HISTORIC AND DESIGN REVIEW COMMISSION

June 02, 2021

HDRC CASE NO: 2021-254
ADDRESS: 223 S ALAMO ST
LEGAL DESCRIPTION: NCB 14016 BLK 9 LOT 14(0.082AC), 16(0.335AC), & S IRR 409.04 FT OF 15(0.36AC)
ZONING: D, H, RIO-3
CITY COUNCIL DIST.: 1
LANDMARK: Hilton Palacio de Rio Hotel
APPLICANT: Andrew Douglas/Douglas Architects
OWNER: Gregory Schry/PALACIO DEL RIO INC
TYPE OF WORK: Landscaping, ADA modifications, patio modifications, stone wall removal and modifications, storefront modifications
APPLICATION RECEIVED: May 13, 2021
60-DAY REVIEW: Not applicable due to City Council Emergency Orders
CASE MANAGER: Edward Hall
REQUEST:

The applicant is requesting conceptual approval to:

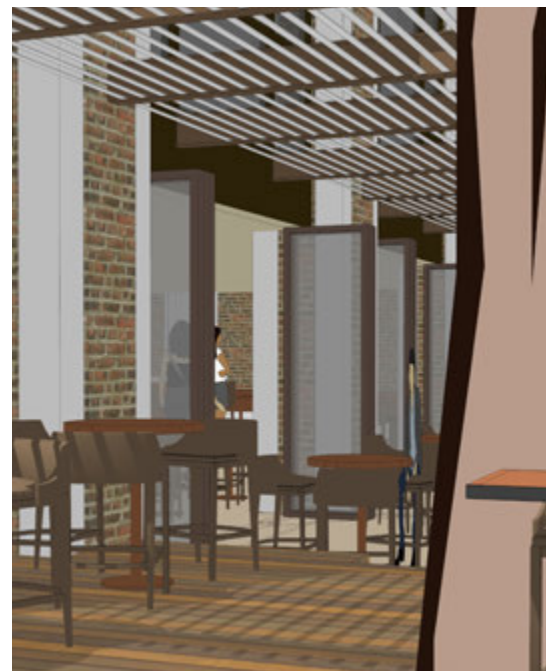
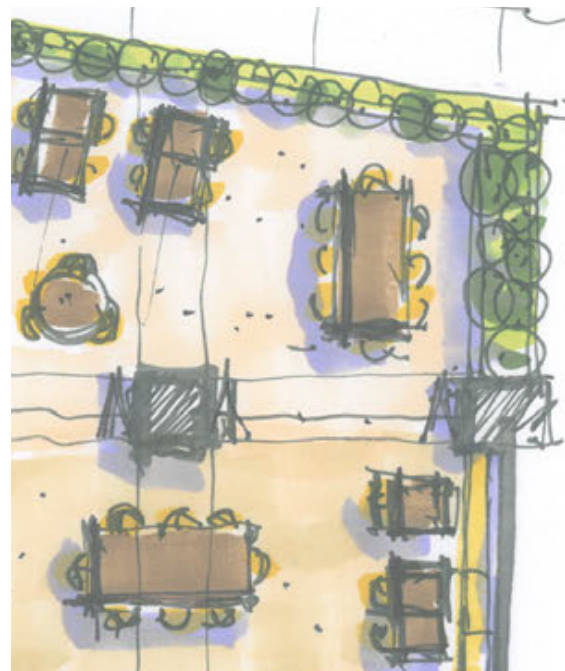
JF: How wide is planting bed? (18 inches) - a planting bed that narrow adjacent to a major walking surface will not be successful.

MS: The existing patio benefits from elevation change as it separates the public space from private

JF: What would help to understand the project are cross sections beginning at the north end of the terrace to the river level. Submit site sections as well to show the relationship from interior to exterior dining to sidewalk to river. Also determine the extent of the sloped walk. How long based on existing grades.

CF: Is the new trellis overhanging the River Walk – is this correct? No, trellis will not enter the River Walk.

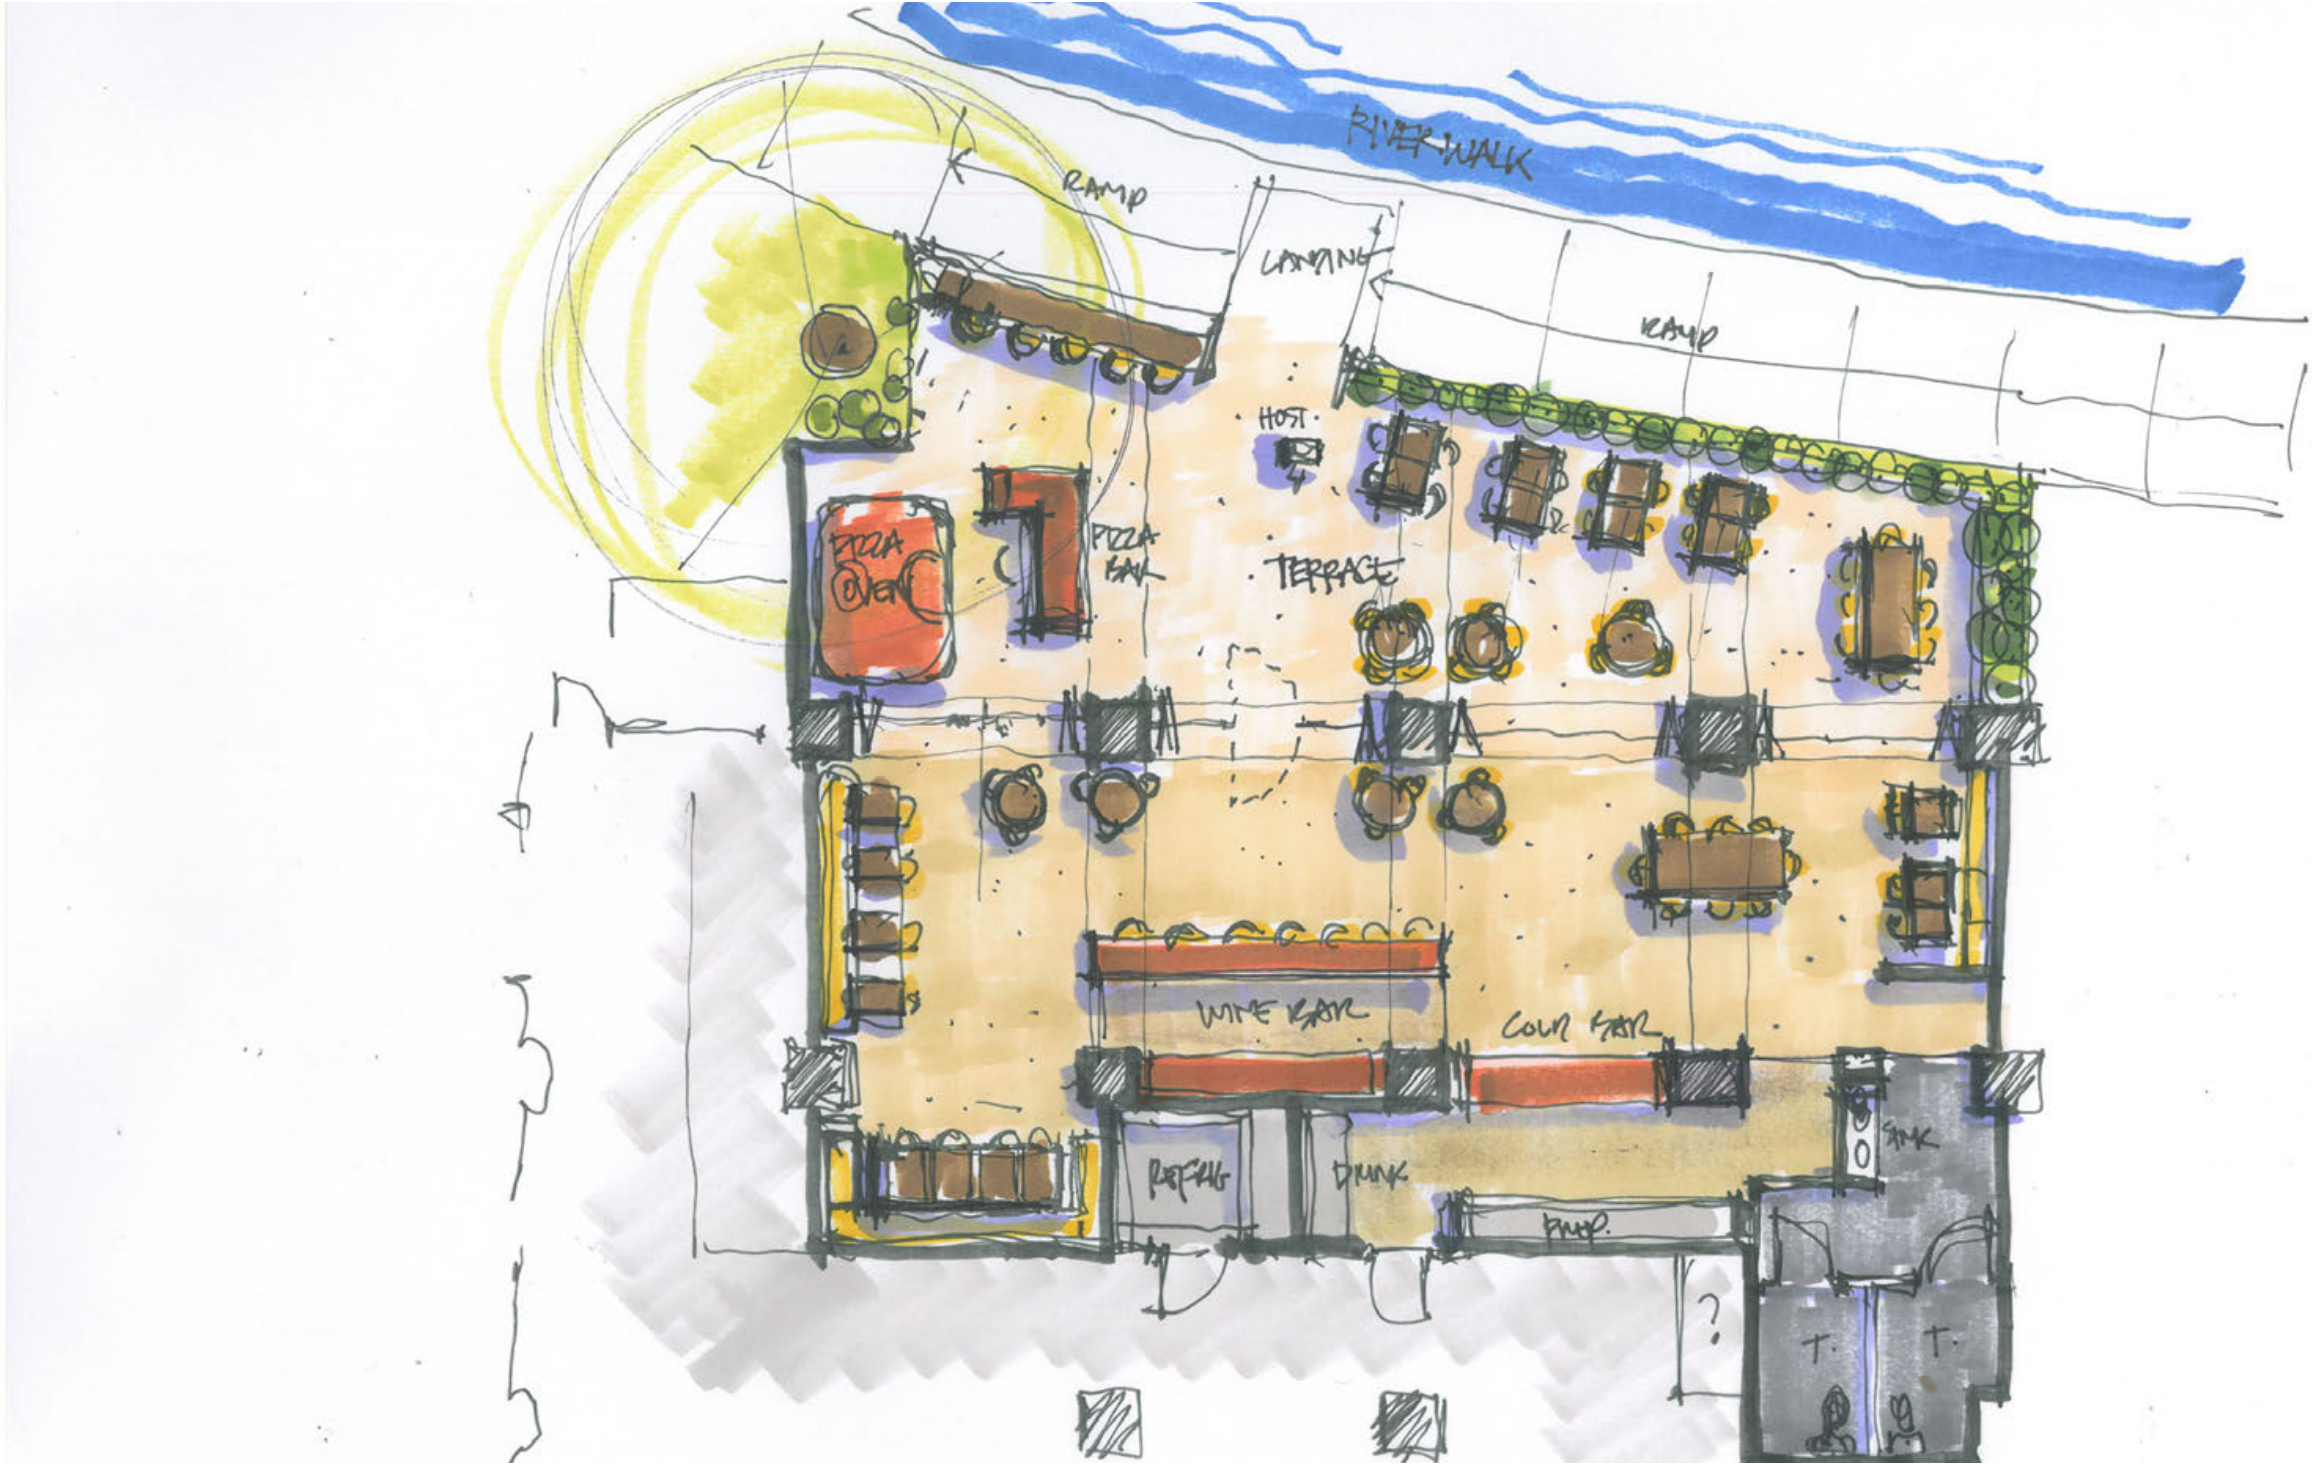
- c. STONE WALL REMOVAL – The applicant has proposed to remove two sections of an existing, low grade stone wall that is located parallel to the pathway at the River Walk. The existing wall that is proposed to be removed feature two sections which are currently separated by a river level pedestrian entrance into the existing patio. This wall is not found on the Hugman construction documents for the Improvement of the San Antonio River; however, staff finds both sections of the wall to relate to the Hugman design as they serve as both a physical and visual barrier between with River Walk path and the existing patio. Staff finds that given the design and materials of the existing wall, it should be preserved to maintain the existing context and relationship to the Hugman Design.

- e. PATIO EXTENSION – The applicant has proposed to extend the existing patio at the river level to the north and remove a section of stone wall within the patio space at the southern end of the property. The northern extension of the patio will also require the remove of a wall perpendicular to the stone wall that runs parallel to the River Walk path. Generally, staff finds the proposed patio extension as well as the removal of the northern wall and modification to the southern wall to be appropriate, as these walls are not believed to be original Hugman elements and their removal will not immediately impact the pedestrian experience at the River Walk path.

- 3. Staff recommends approval of item #3, the extension of the patio as well as the removal and modifications to two stone walls that are perpendicular to the stone wall at the River Walk path, based on finding e.
